Clinton Power Station, Unit 1
Facility Operating License No. NPF-62
NRC Docket No. 50-461

Subject: Second Six-Month Status Report in Response to March 12, 2012 Commission Order Modifying Licenses with Regard to Requirements for Mitigation Strategies for Beyond-Design-Basis External Events (Order Number EA-12-049)

**Second Six-Month Status Report for the Implementation of Order EA-12-049, Order
Modifying Licenses with Regard to Requirements for Mitigation Strategies for Beyond-
Design-Basis External Events**

Figure 1
RCIC Operation During Phase 2

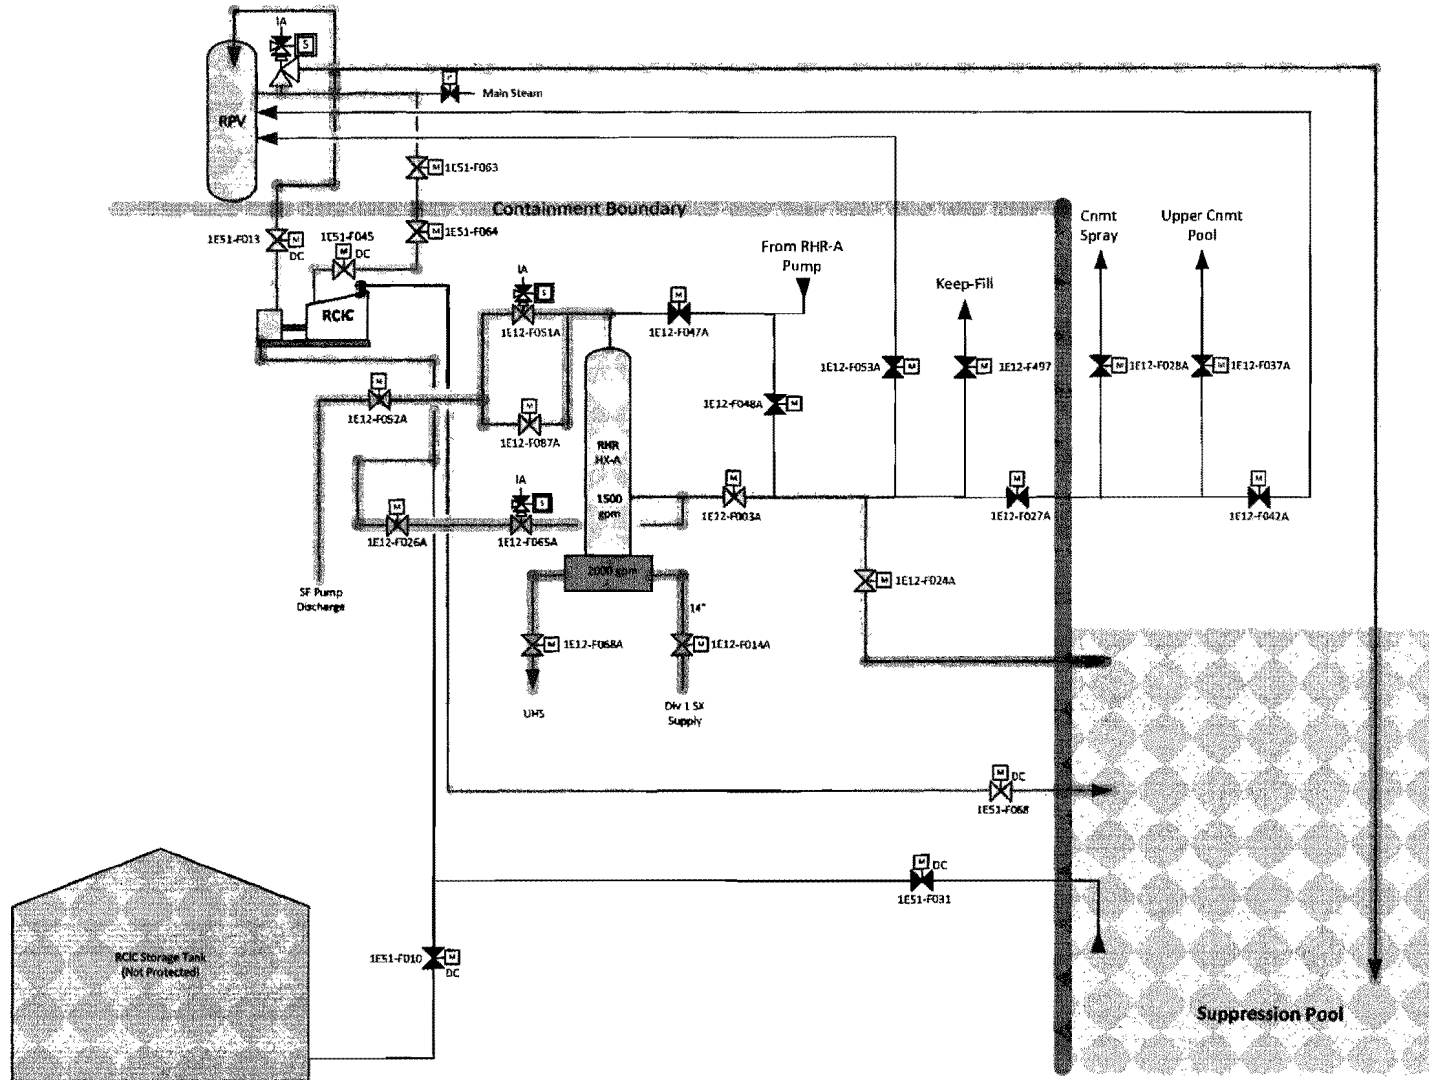
Once the suppression pool lineup is completed, RCIC suction will be shifted to the RHR heat exchanger shell outlet using installed RHR steam condensing mode piping (Figure 1). This action limits the RCIC system exposure to elevated suppression pool temperature to the first eight hours of the event. The maximum water temperature the RCIC pump is exposed to is 200.7°F according to the MAAP analysis. Once the RCIC suction is shifted the RCIC suction water temperature is 138°F .

Figure 3
Supply from Ultimate Heat Sink

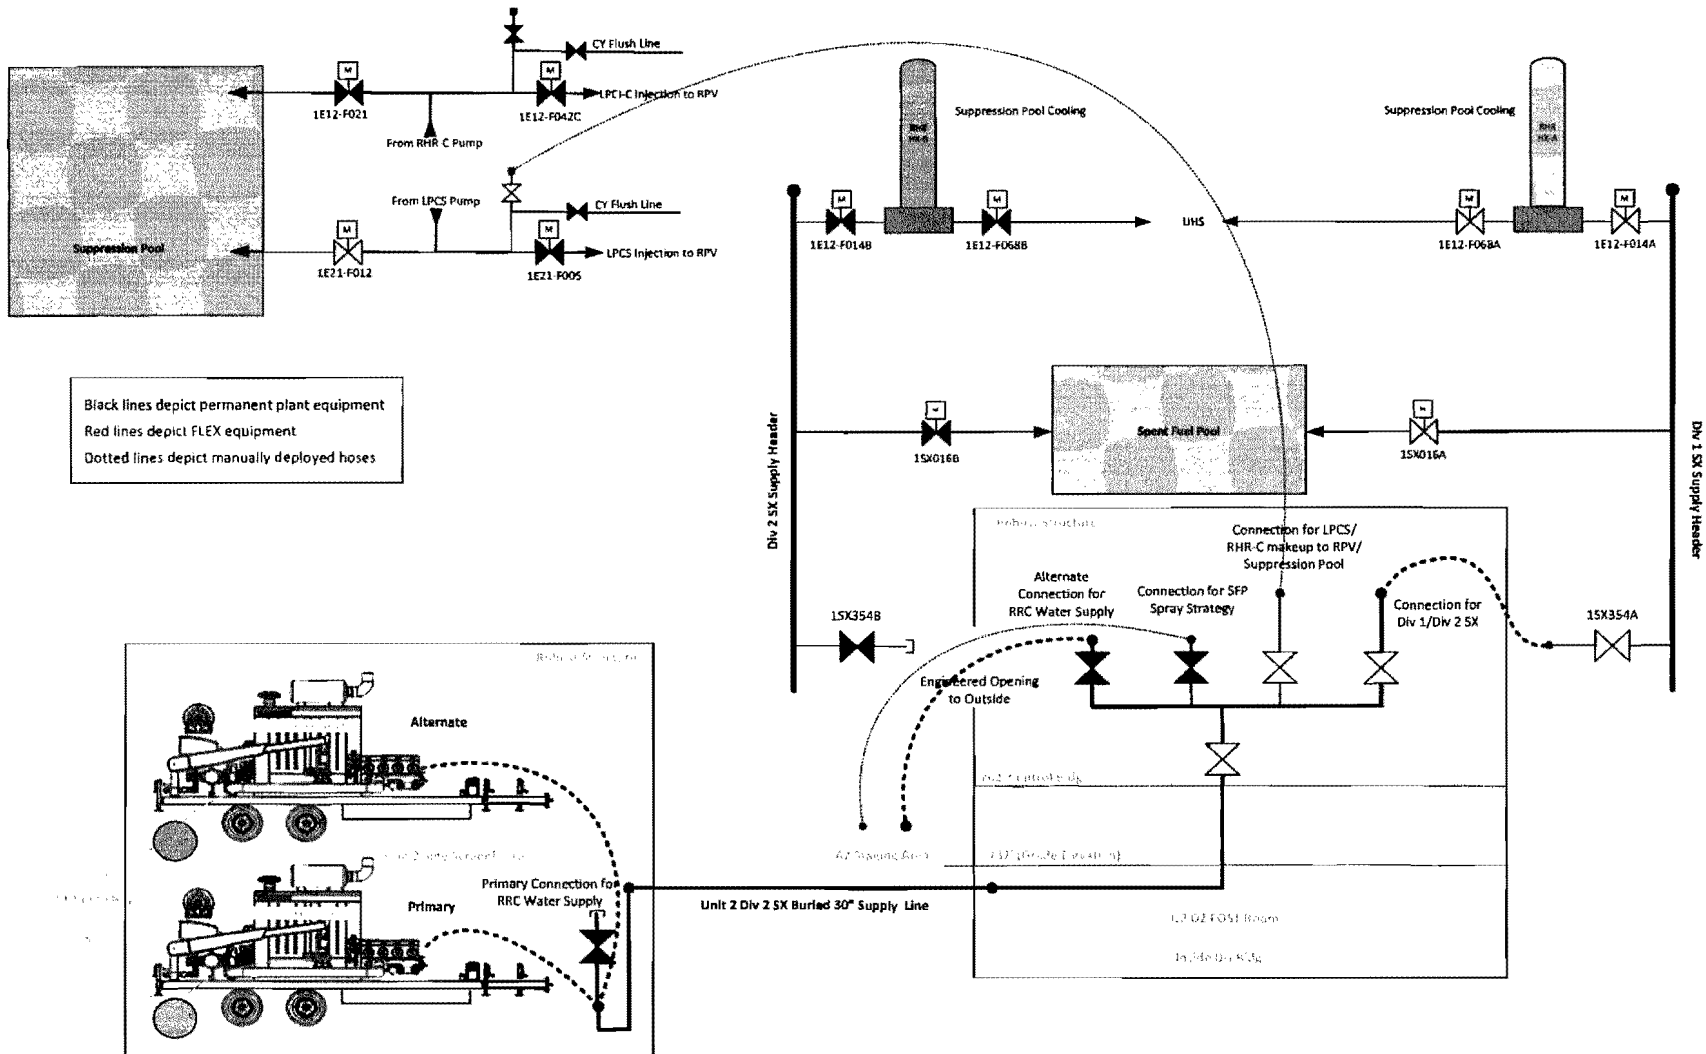
To accomplish low pressure RPV makeup when RCIC is no longer available, the suppression pool cooling return path can be directed to the RPV using installed RHR system LPCI valve. Additionally, external water connections will be provided to a location that supports connection to the modified Low Pressure Core Spray (LPCS) [Reference 8] and the Residual Heat Removal (RHR) C [Reference 9] injection header. A pre-staged section of fire hose allows the final connection from the external water supply to the injection header (see Figure 3). The injection valves for these two systems are located outside the

<i>the protected Control Building.</i>
Cooling/Makeup Water Support (Figure 3)		
The diesel driven pumps will be housed in a storage structure that meets NEI 12-06 Rev.0 storage requirements. A heavy duty truck capable of clearing debris will be stored in the same location.	Two external water connections.	<p>Phase 2</p> <p><i>The FLEX mechanical connections will be completed inside the Control Building, which is protected from all external hazards.</i></p> <p>Phase 3</p> <p><i>The mechanical connection for an external pump from the Regional Response Center (RRC), if needed, to the SX system will be inside a robust building on the Unit 2 side of the Screen House adjacent to the "A1" staging area.</i></p> <p><i>An alternate connection will be deployed from within the Diesel Generator Building through an engineered opening in the external wall to the outside "A2" staging area using a hose pre-staged for this purpose inside the protected Diesel Generator Building.</i></p>

Figure 4
Electrical Strategy

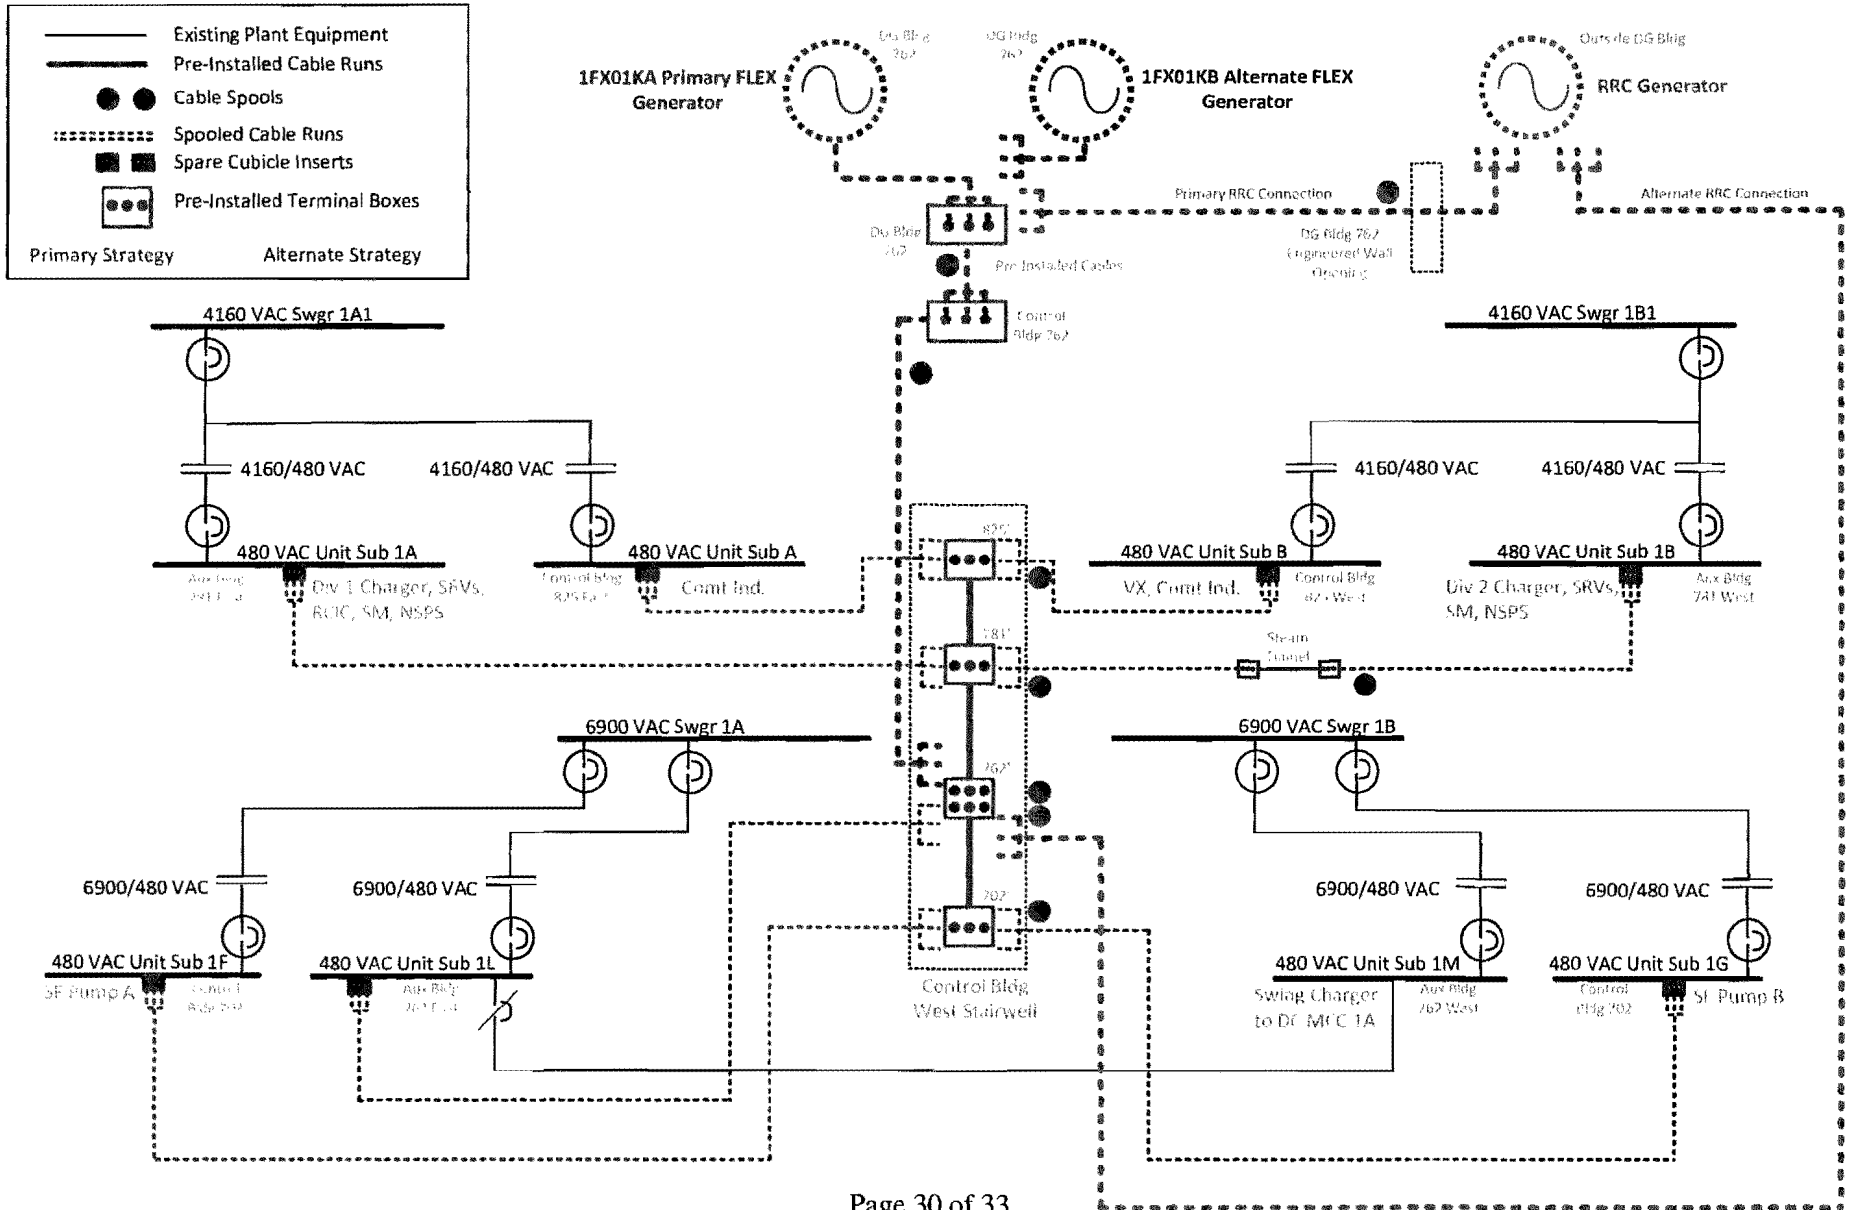
Key portions of the Division 1, Division 2, and non-divisional 480 VAC distribution system will be able to be re-energized from a pre-staged primary or alternate FLEX generator. Either generator independently will enable maintaining DC power for RCIC, SRV controls and vital instrumentation, and provide AC power for hydrogen igniters, SPMU valves and Suppression Pool Cleanup and Transfer pumps (Figure 4).

Figure 5
FLEX ADS Air Supply

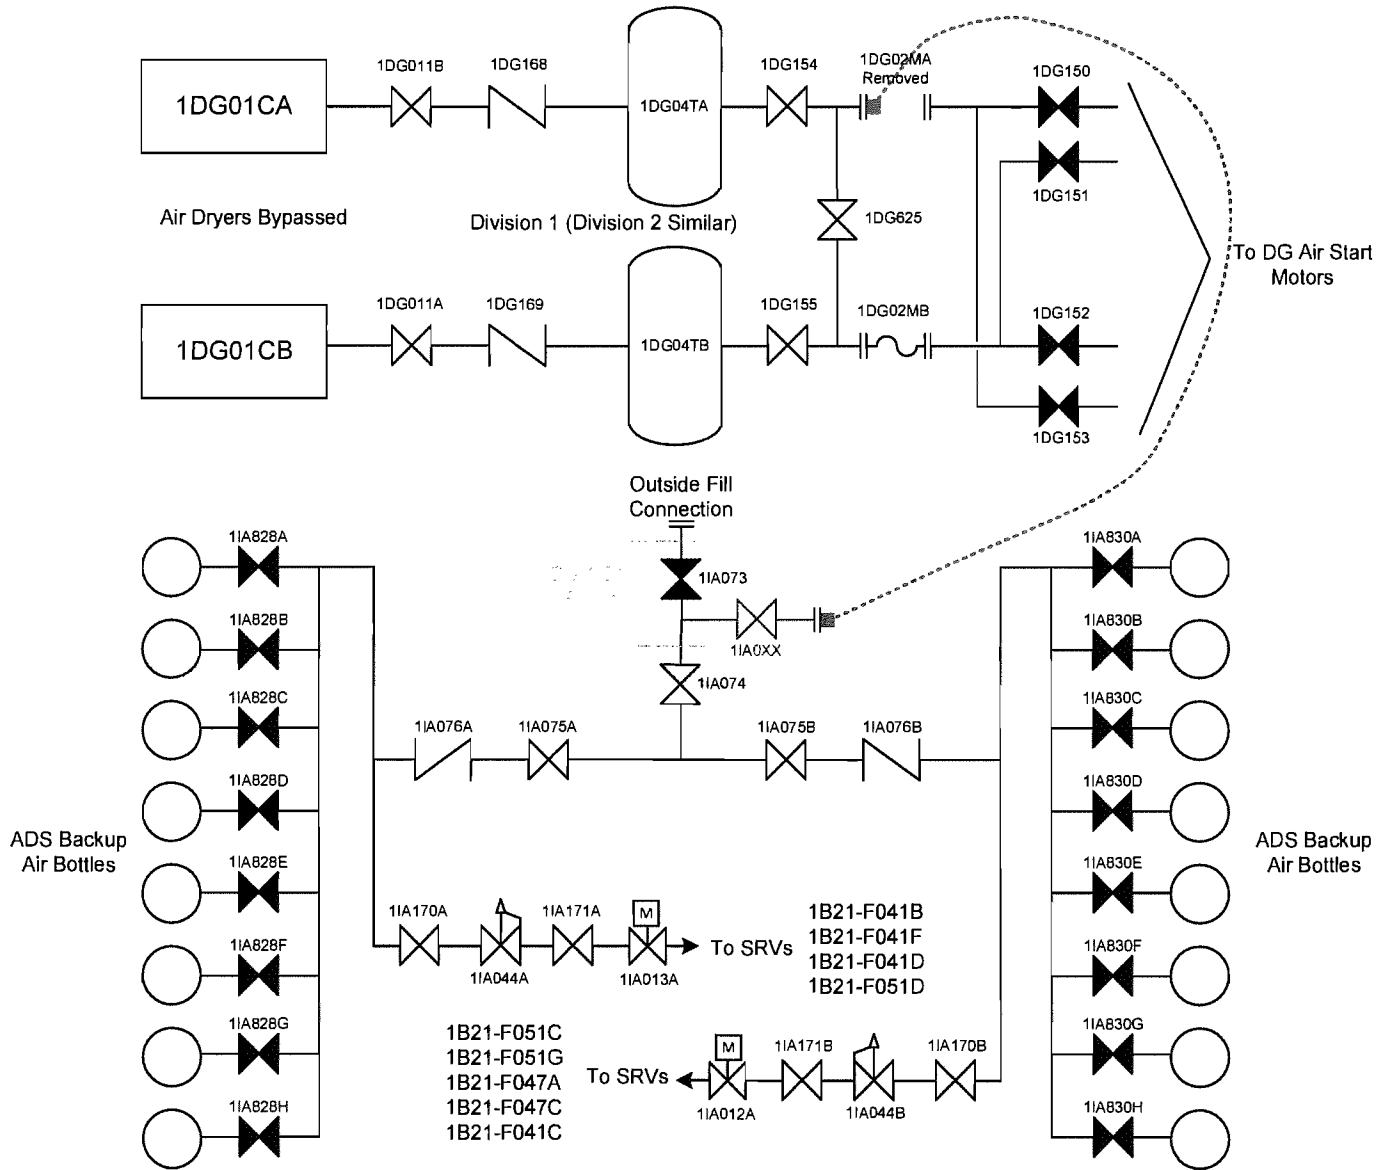
Change: During Phase 2, high pressure RPV makeup is provided from RCIC and RPV pressure control is provided from RCIC and the SRVs. A pre-staged 480 VAC generator will be lined up to the Division 1 AC distribution system to repower the Division 1 battery charger and enable the continued use of RCIC, SRVs, and vital instrumentation. *An installed Diesel Generator Starting Air Compressor will be aligned to make up to the ADS backup air bottles, if required (Figure 5).*

Reason for Change: Clinton identified a simpler method (Figure 5) of supplying air to ADS valves when the Backup Air Bottles are exhausted.
